ADDENDUM NUMBER 4

**LINCOLN COMPLEX – BUILDING O O.A.R., LIBRARY SERVICES AND I.T.
RENOVATIONS
930-B Oak Street SE, Albuquerque, NM 87106
ALBUQUERQUE PUBLIC SCHOOLS**

APS RFP No. 21-031-RRR

Date of Issue: 12/15/2020

A-106

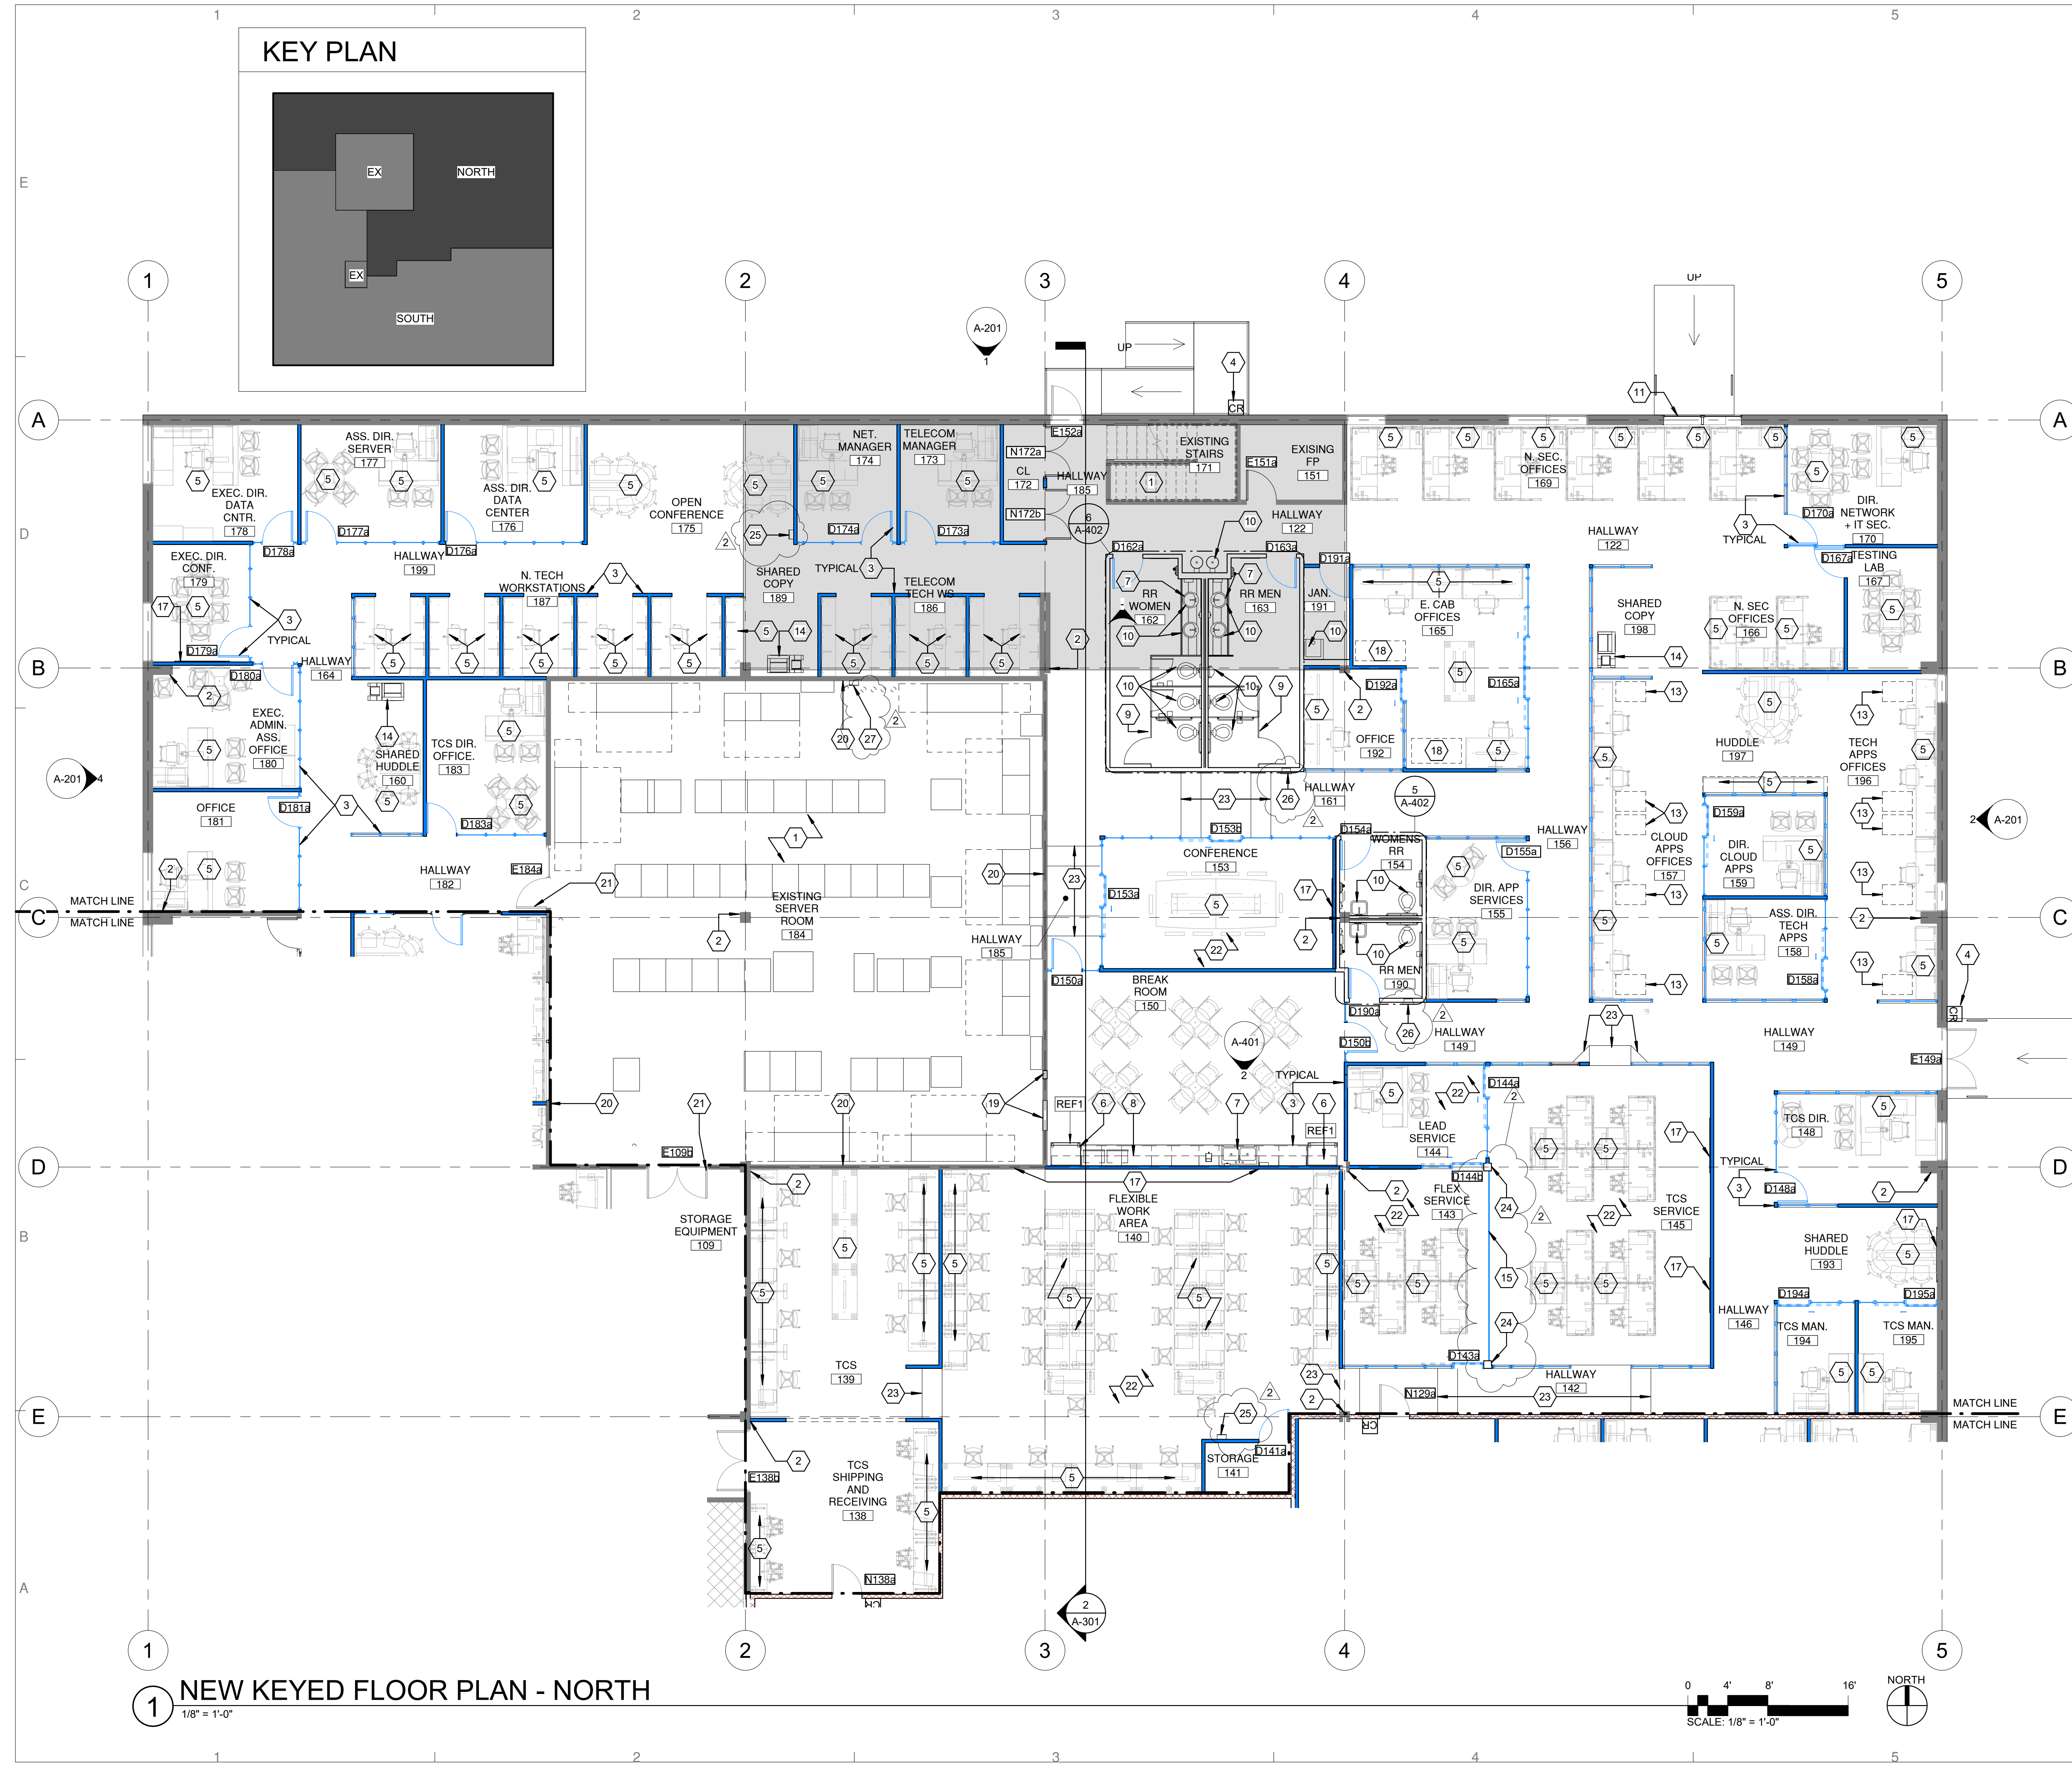
- 5) Addition: fire extinguishers and fire extinguisher cabinets are located and noted on sheets A-105 and A-106.
- 6) Clarification: change the appliance schedule to be referenced to sheet, A-402.

A-107
SHEET ___ OF ___

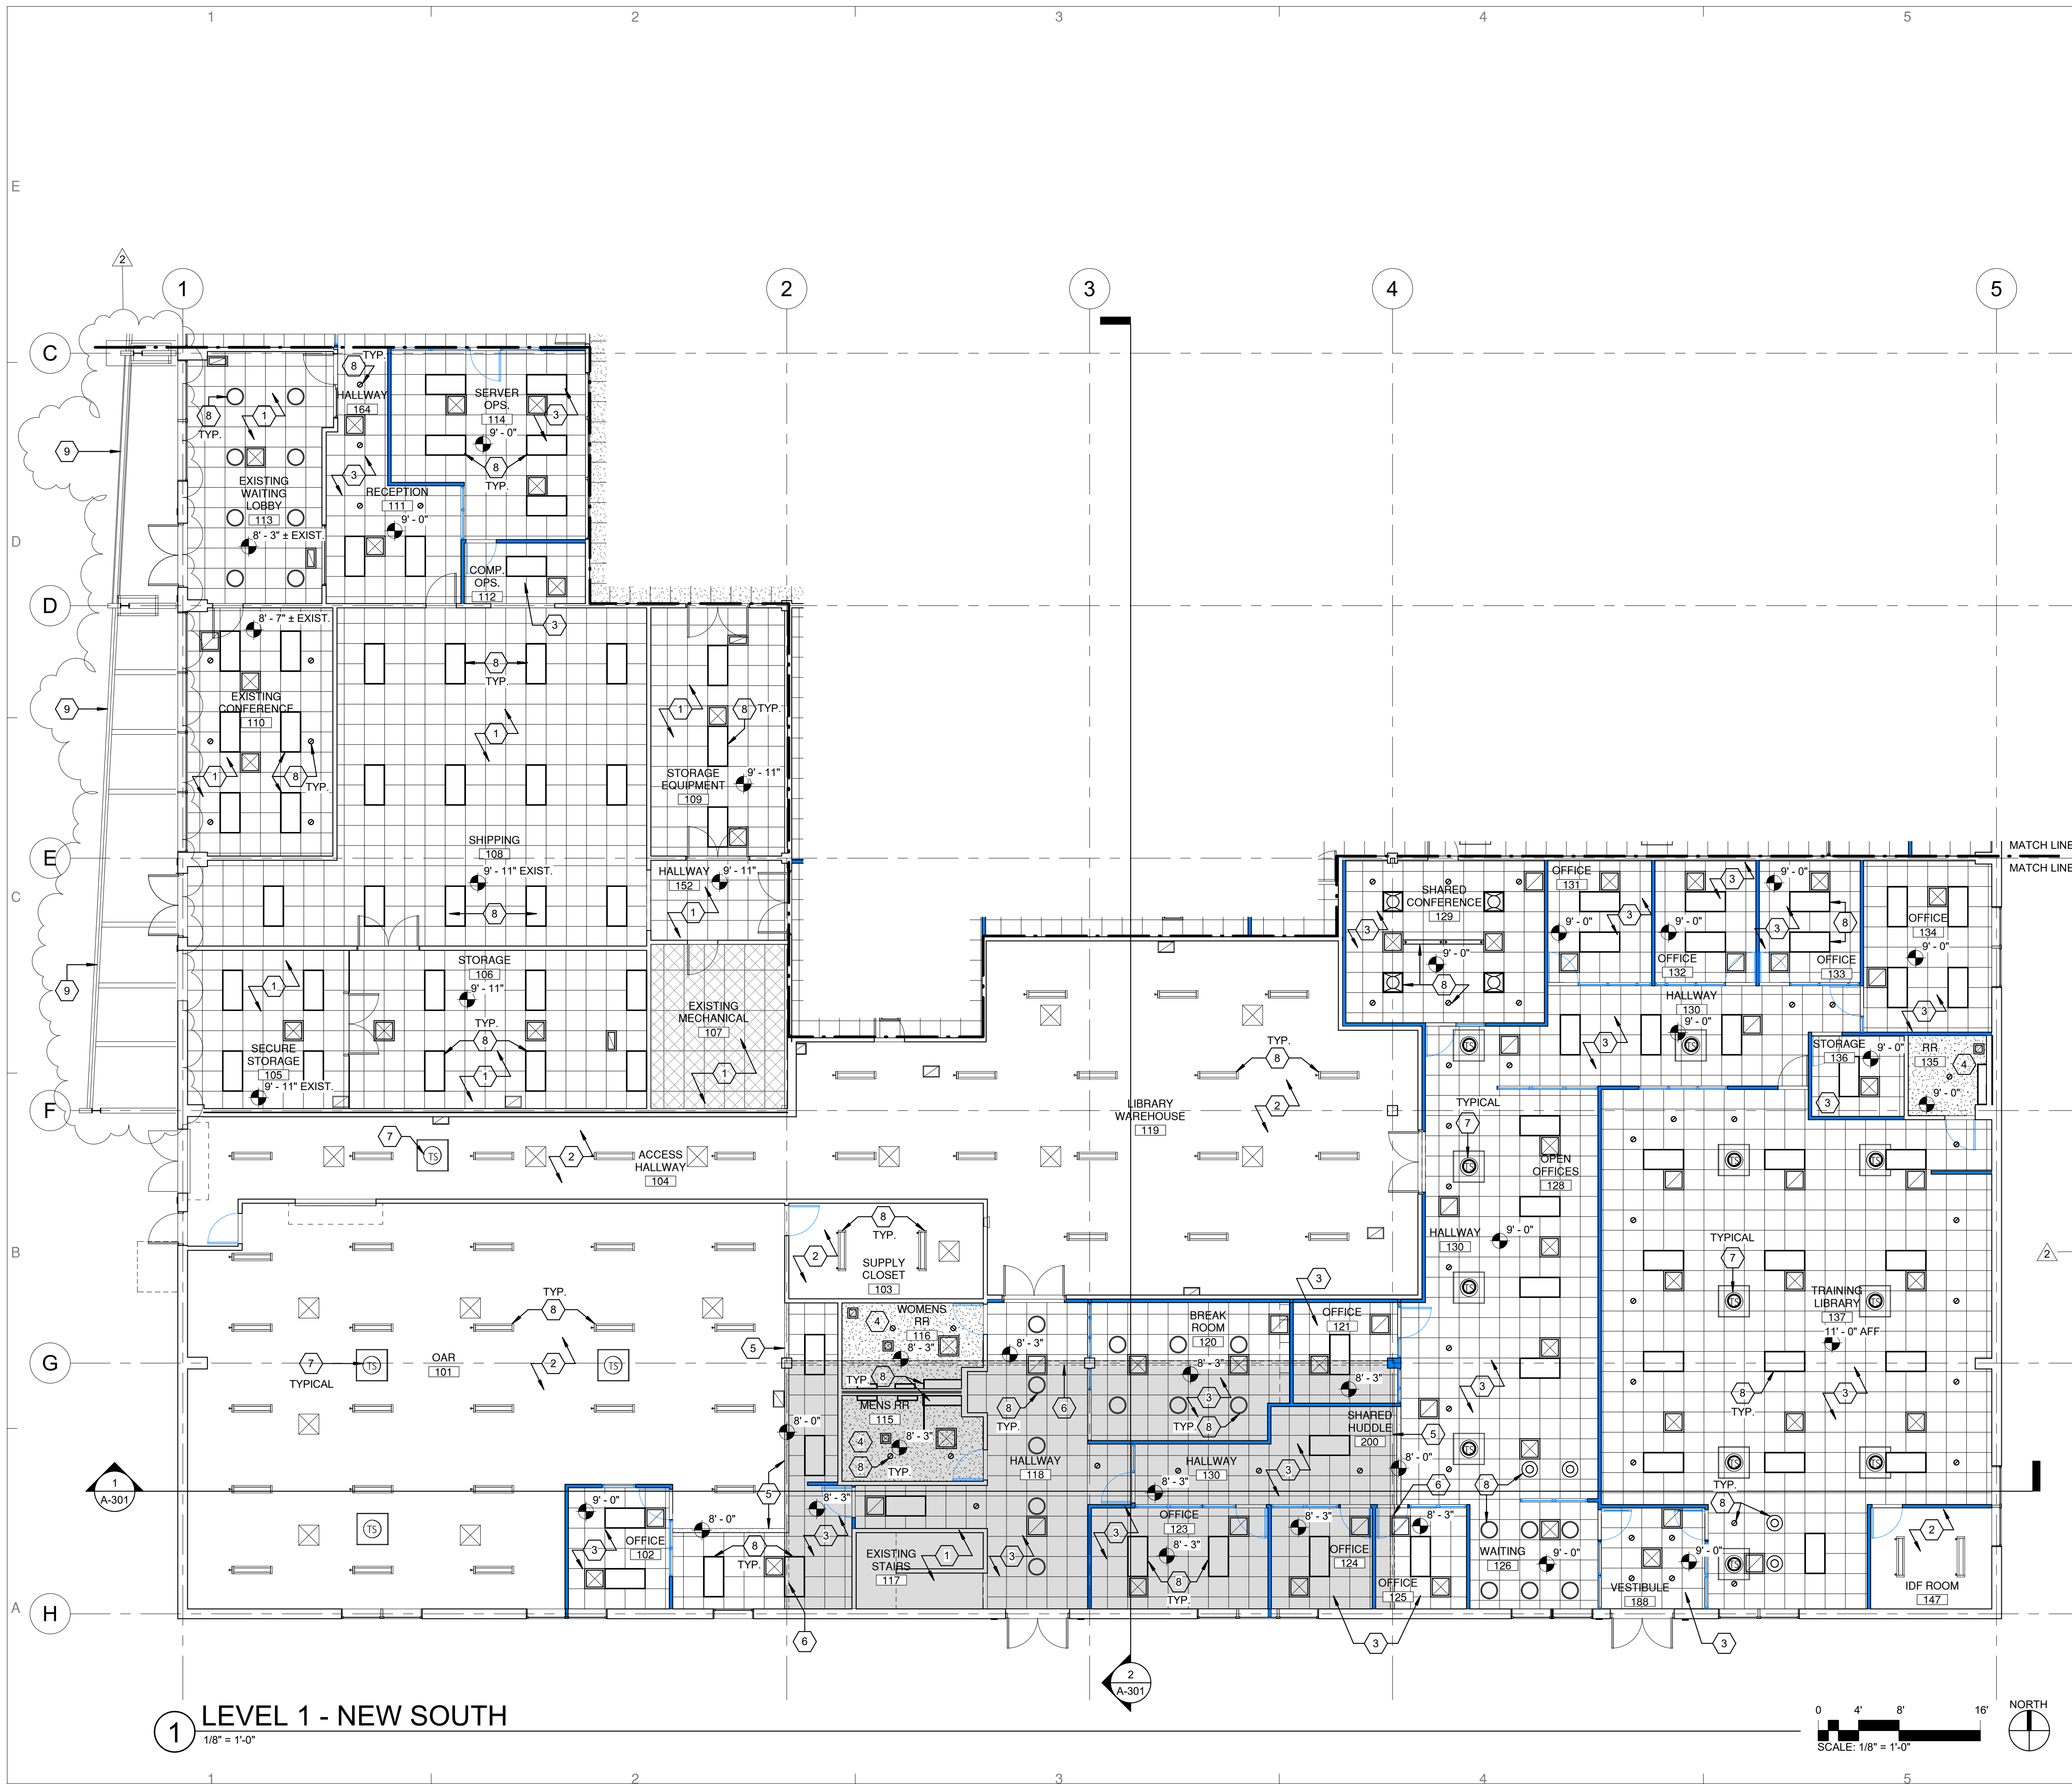
- 4) Clarification of existing metal canopy on west side of building: see sheet A-105 and A-107 for new keyed notes to indicate that the existing metal canopy will be included as part of Bid Lot 2 for painting.

A-401

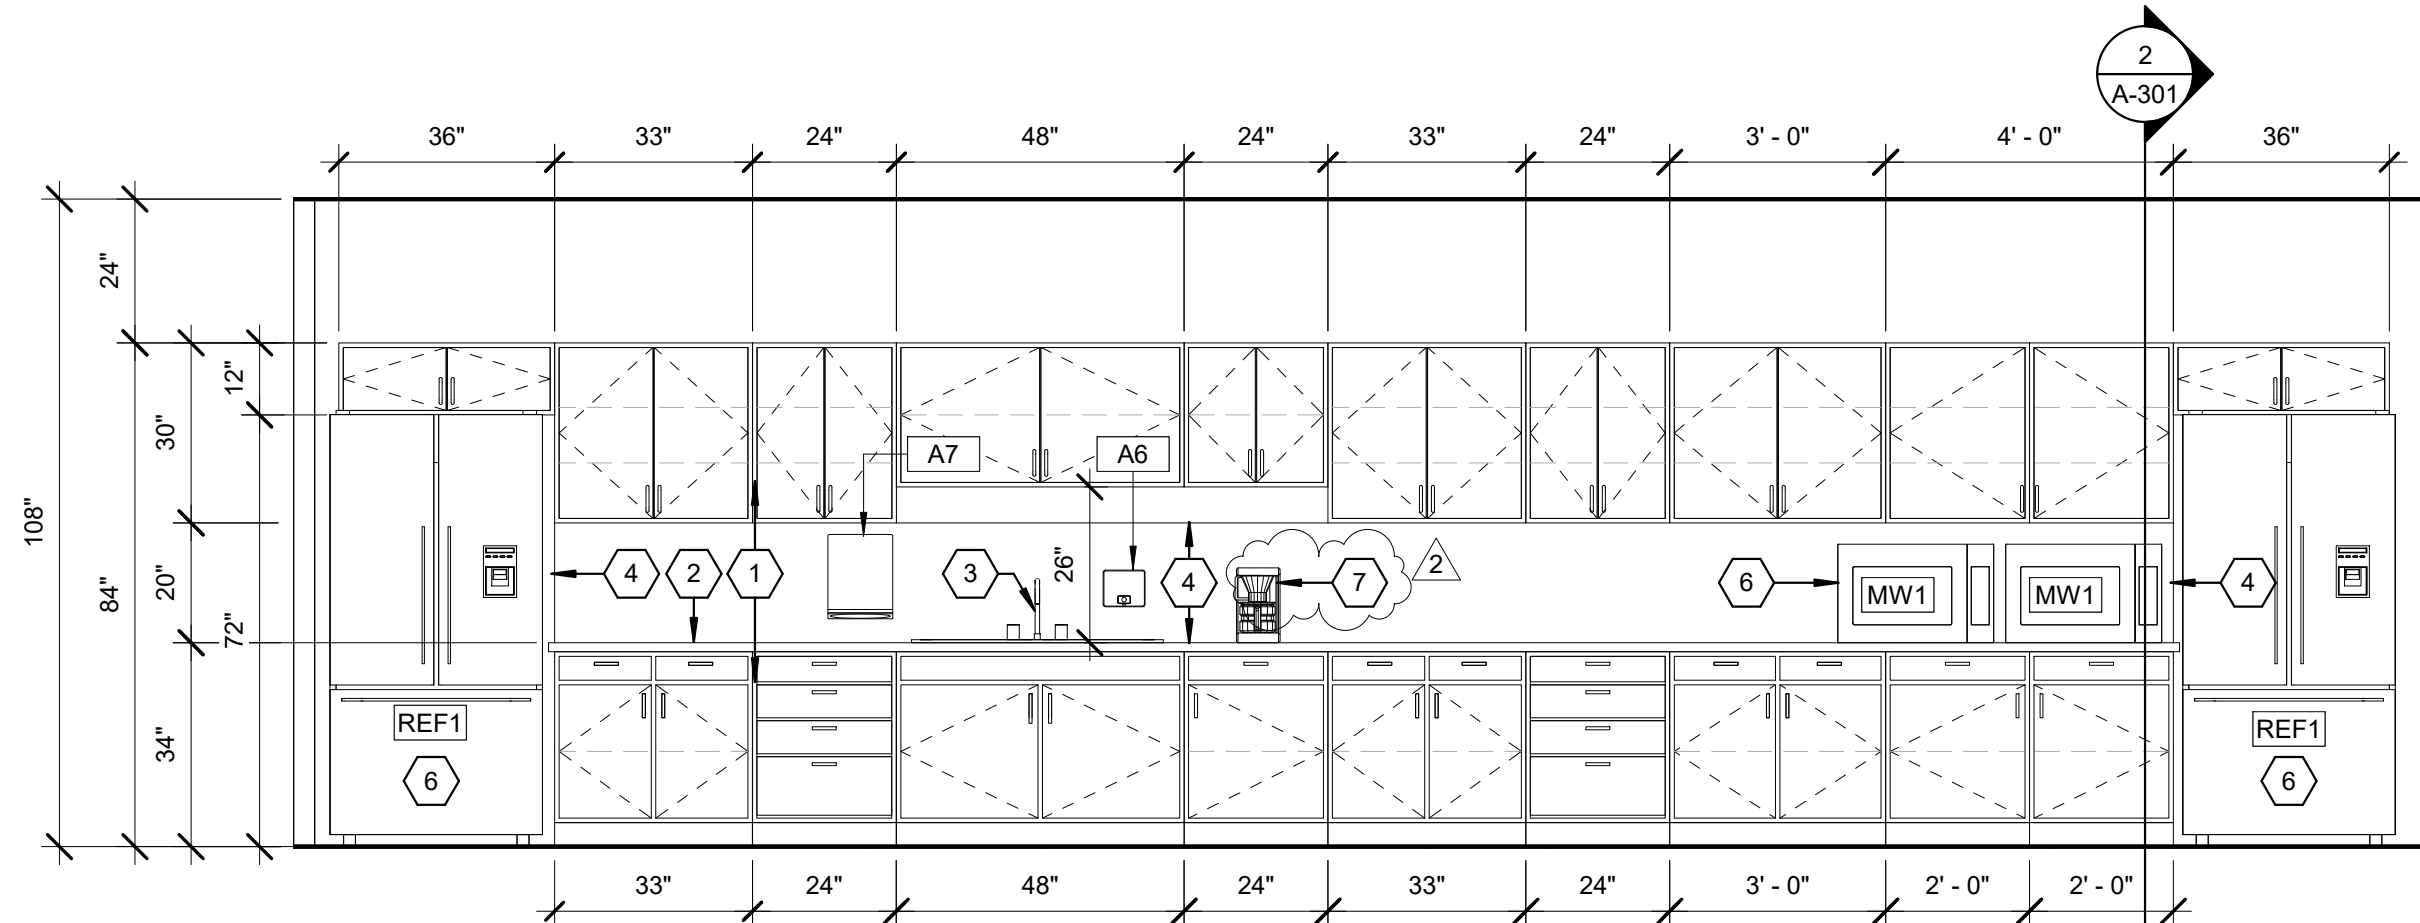
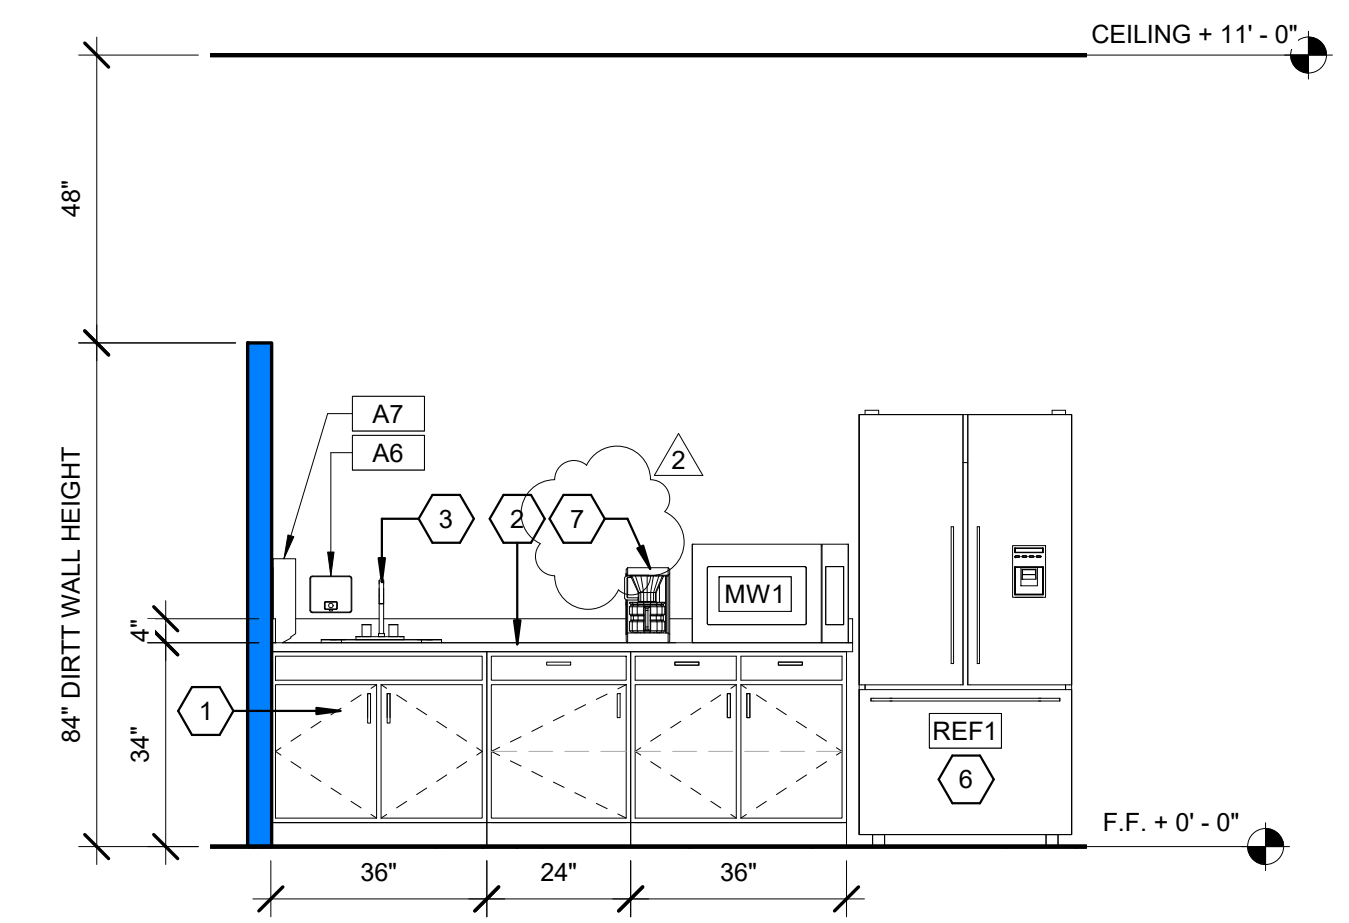
- 7) Clarification on A-401 Interior Elevations for coffee makers: coffee makers are to be by APS. See keynote 7 on sheet A-401 for this clarification.
